**SOUTH DUBLIN COUNTY COUNCIL'S PLANNING AUTHORITY'S REPORT TO
AN BORD PLEANALA ON**

APPLICATION FOR FURTHER DEVELOPMENT CONSENT UNDER SECTION 37L

**AT BEHAN'S QUARRY
WINDMILL HILL, RATHCOOLE, COUNTY DUBLIN**

**Land Use Planning and Transportation Department
South Dublin County Council
County Hall
Tallaght, Dublin 24
Prepared by: Tracy McGibbon
Date of Report: 18th August 2021**

Figure 4.1

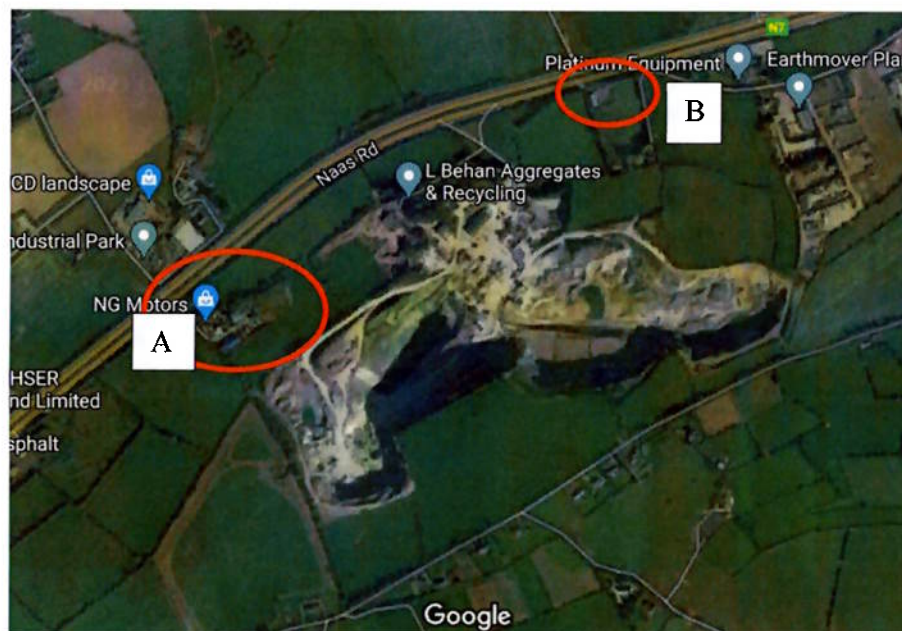
- 4.5.2 The Planning Authority also notes and would like to draw the Board's attention to commercial activities that are alleged to be taking place to the north and west of lands outlined in blue within the ownership of the applicant. **[Circled and labelled A on Figure 4.1]**. The lands take access from the Naas Road (N7). No planning history can be traced to these lands and a recommendation has been sent to South Dublin County Council's Enforcement department to investigate these works and commercial uses on rural zoned lands.

- 4.5.3 The Planning Authority also notes alleged unauthorised development, works and uses that have taken place on lands outlined in blue located to the north and east of the overall landholding. **[Circled and labelled B on Figure 4.1]** The site is located off the N7 (with an agricultural entrance in place). The development constructed on site appears to take access off the historic Naas Road, now cul-de-sac'd. No planning history can be traced to these lands and a recommendation has been sent to South Dublin County Council's Enforcement department to investigate these works and uses on rural zoned lands.

Figure 4.1

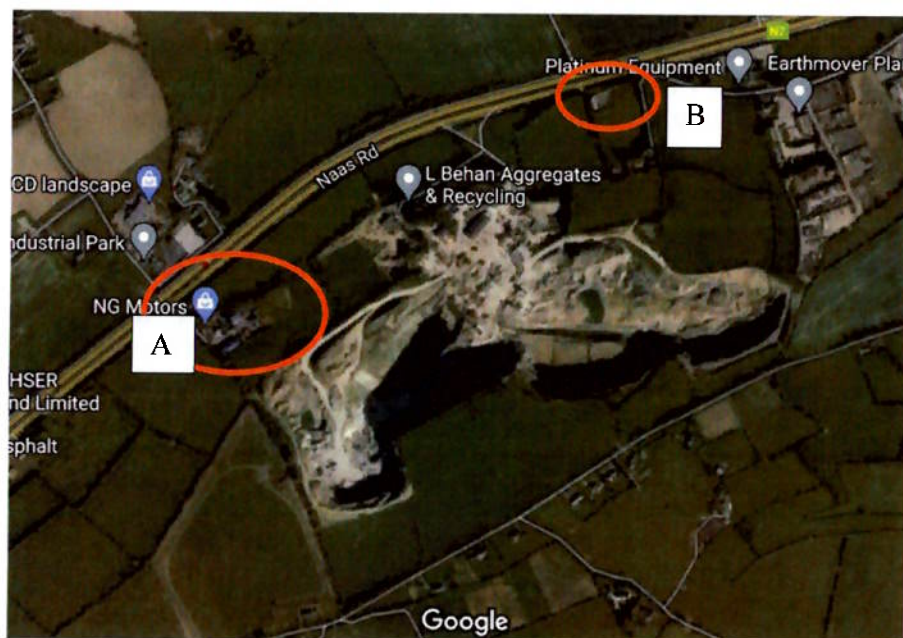
- 4.5.2** The Planning Authority also notes and would like to draw the Board's attention to commercial activities that are alleged to be taking place to the north and west of lands outlined in blue within the ownership of the applicant. **[Circled and labelled A on Figure 4.1]**. The lands take access from the Naas Road (N7). No planning history can be traced to these lands and a recommendation has been sent to South Dublin County Council's Enforcement department to investigate these works and commercial uses on rural zoned lands.

- 4.5.3** The Planning Authority also notes alleged unauthorised development, works and uses that have taken place on lands outlined in blue located to the north and east of the overall landholding. **[Circled and labelled B on Figure 4.1]** The site is located off the N7 (with an agricultural entrance in place). The development constructed on site appears to take access off the historic Naas Road, now cul-de-sac'd. No planning history can be traced to these lands and a recommendation has been sent to South Dublin County Council's Enforcement department to investigate these works and uses on rural zoned lands.
